# **GENERAC**<sup>®</sup>

**P**RODUCT **I**NFORMATION **B**ULLETINS,

EFFECTIVE DATE  
MAY 1997

Figure 1

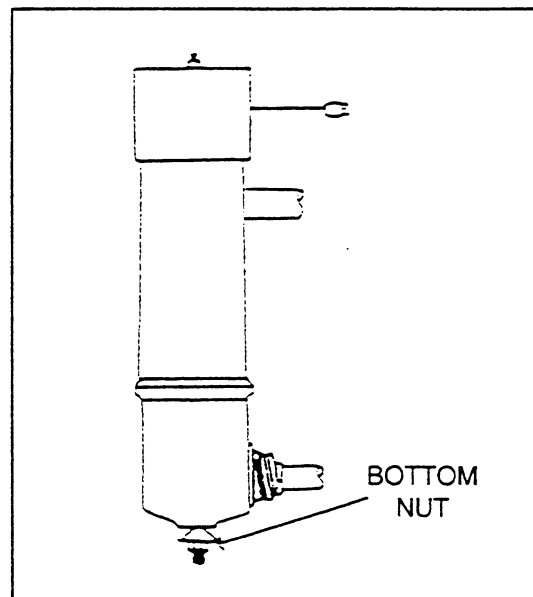
SUBJECT: Possible block heater leaks.

- 1) Start the generator and allow ten minutes for warm-up.
- 2) After the ten minute warm-up period, shut the generator down. Torque the bottom nut to 6 (six) foot-pounds. (See Figure 1 below).

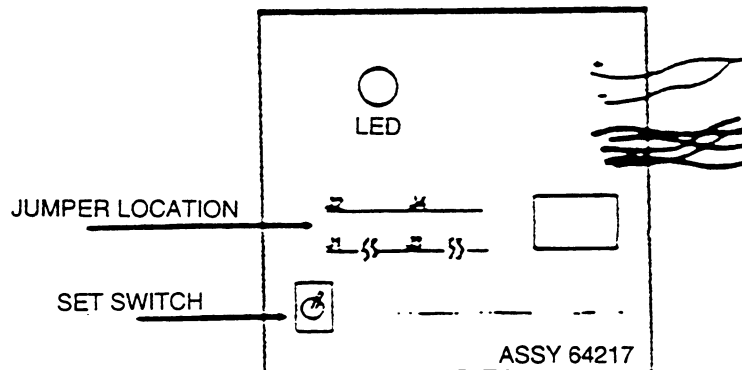
SUBJECT: Abnormal or non-exercising cycle.

- 1) For a 60 Hertz system, cut jumpers J2 and J4, as shown below.

- 2) For a 50 Hertz system, cut jumpers J1 and J3, as shown below.

FIGURE 1

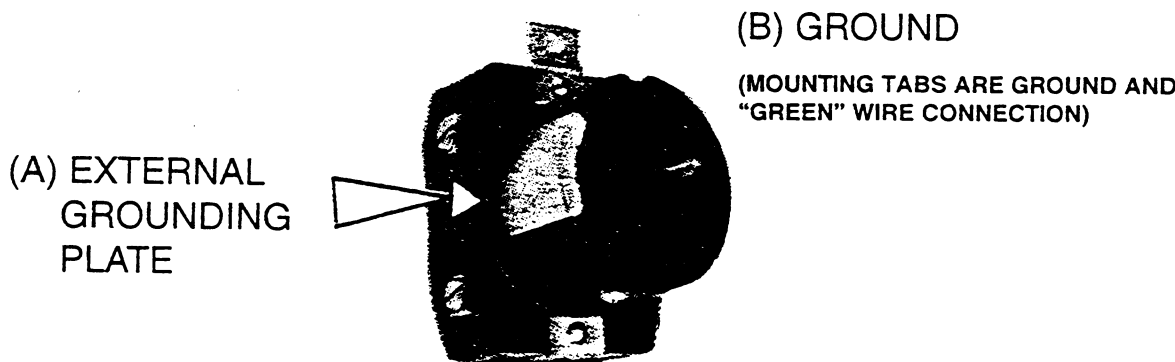
PROBLEM: There may be some 50 AMP receptacles in the field (Figure #1) which do not have a physical connection between the grounding plate on receptacle ("A") and ground of the generator ("B"). This connection is internal.

**CORRECTIVE ACTION:** With a multi meter set on the RX1 scale make a continuity check between the plate on receptacle ("A") and the mounting screws for the receptacle (Generator ground). There should be a reading between the two. If there is no reading replace the receptacle immediately (Part # 79486) DO NOT ALLOW THE USAGE OF THE DAMAGED RECEPTACLE.

FIGURE 1

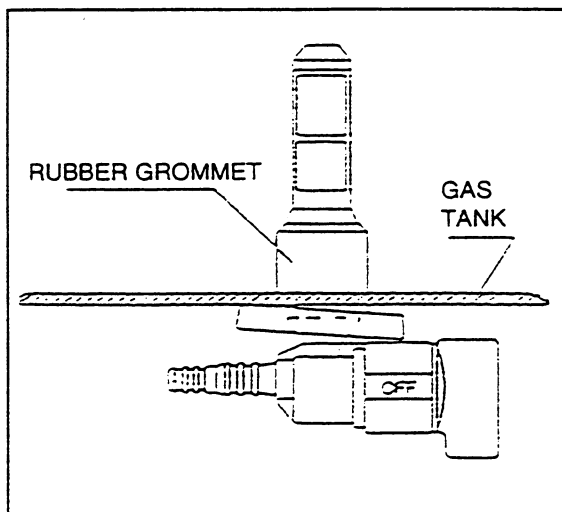
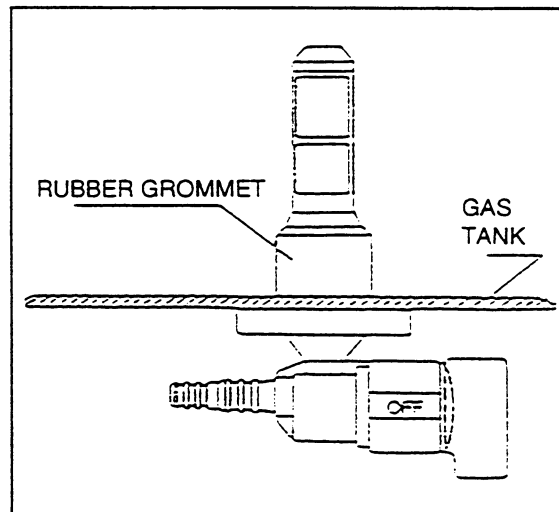
**PROBLEM:** Over insertion of the fuel shut-off valve into the rubber grommet can cause elongation of the fuel outlet on the tank. The fuel shut-off valve has a stop built into it, but we have seen the fuel shut-off valve pushed beyond the stop (Figure 1).

**CORRECTIVE ACTION:** If you encounter this situation on any unit, a new tank assembly (88325) should be installed. Order the parts through your regular source of supply (Figure 2 shows properly installed fuel shut-off valve).

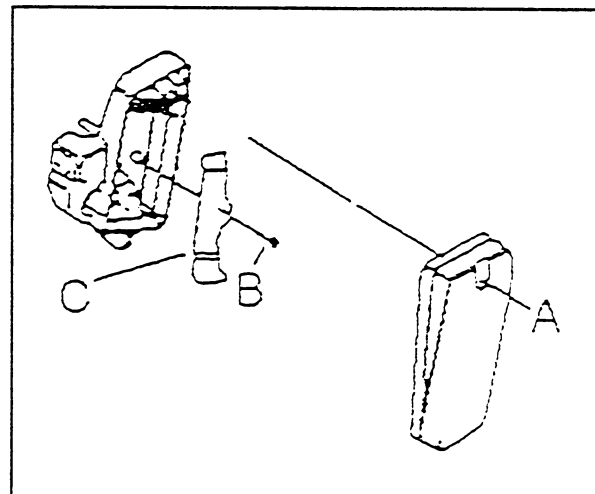
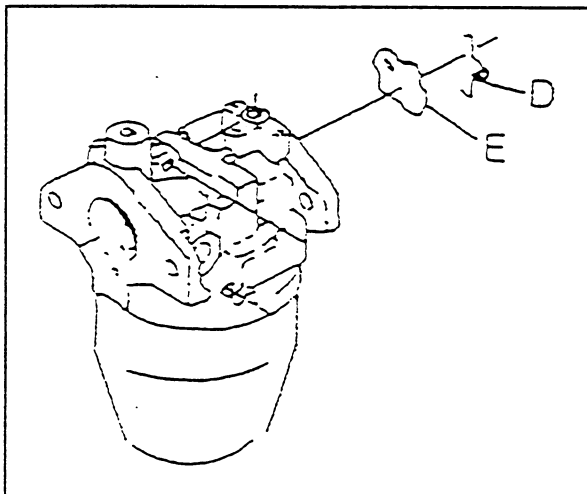
PROBLEM: If you receive a customer complaint of hard starting in cold weather (35 degrees or less) and you have eliminated all other possibilities such as ignition, choke adj., fuel, etc., it may be necessary to replace the choke plate.

CORRECTIVE ACTION: A recalibrated choke plate, part number 88768, is now available from your normal Generac parts supplier. This part will eliminate hard starting problems by providing a more rich mixture at full choke. Installation time is less than 15 minutes.

1. Remove air cleaner cover (A).
2. Remove the screw holding the breather cover (B). Use 1/4" nut driver.
3. Remove breather cover (C).
4. With needle nose pliers, carefully remove the choke plate spring retainer (D).
5. Remove choke plate (E).

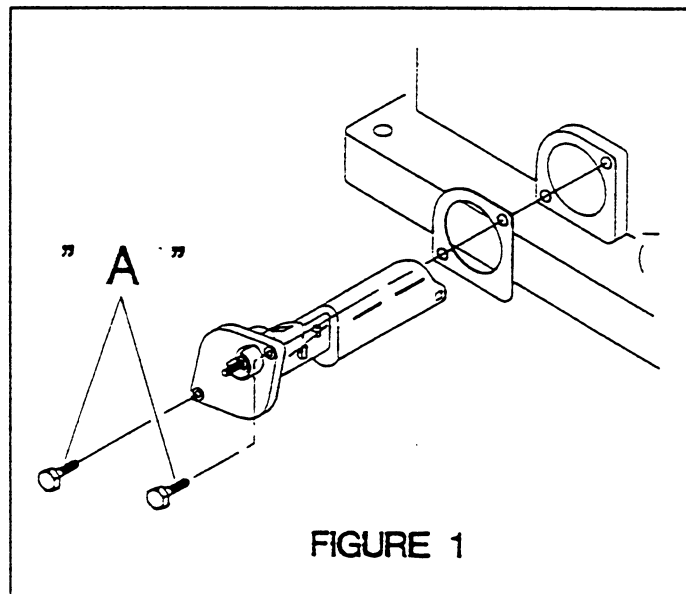
SUBJECT: Low oil level switch mounting screws.

CORRECTIVE ACTION: Replace the original taptite (See figure 1 item "A") Part # 32713 #10-32 x 5/8" with part # 24679 # 10-32 x 3/4".

A) Remove one taptite (Fig. 1 Item "A") and replace. Remove other taptite and replace it. (Torque screws 35 to 45 in. Lbs.)

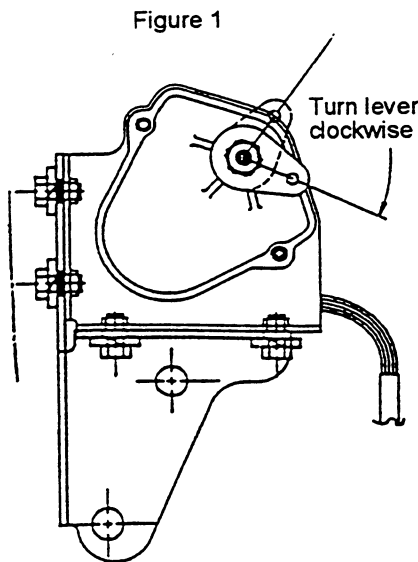
**PROBLEM:** Incorrect position of the lever on stepper motor causing unit not to come up to full speed or carry a load and maintain correct frequency.

- A. Remove the stepper motor.
- B. While holding the stepper motor with the lever facing up, turn the lever clockwise all the way until it stops. **DO NOT FORCE!**
- C. In this position the lever should be in the four o'clock position with the stepper motor orientated as shown in figure 1.
- D. If the lever is not in the four o'clock position, remove the screw and reposition the lever in the four o'clock position as shown in figure 1.
- E. Reinstall the stepper motor, start the generator and readjust engine speeds as follows:
  1. No-load idle control off; 62Hz or 3720 RPM
  2. No-load idle control on; 40-43 Hz or 2400-2580 RPM

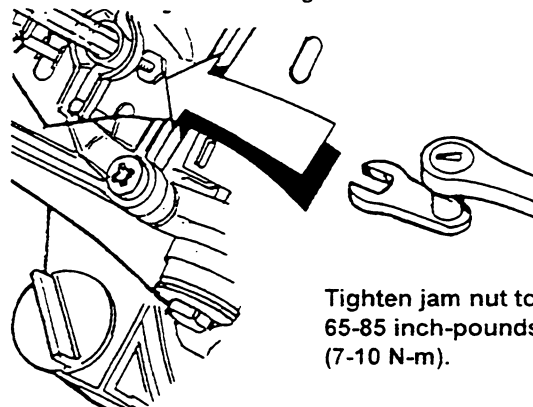
**SUBJECT:** Adjusting valve clearance.

**CORRECTIVE ACTION:** When adjusting the valve clearance, the engine should be at room temperature and the piston should be at top dead center of it's compression stroke (both valves closed). Correct clearance is 0.05 - 0.1mm. Replacement of head gaskets is suggested. The GN190 takes a #77167, the 191, and 220 engines take a #88397; 320, 360, and 410 engines take a #71987 head gasket. Adjust the valve as follows:

1. Loosen the rocker arm jam nut. Use an allen wrench to turn the pivot ball stud while checking the clearance between the rocker arm and the valve stem with a feeler gauge.
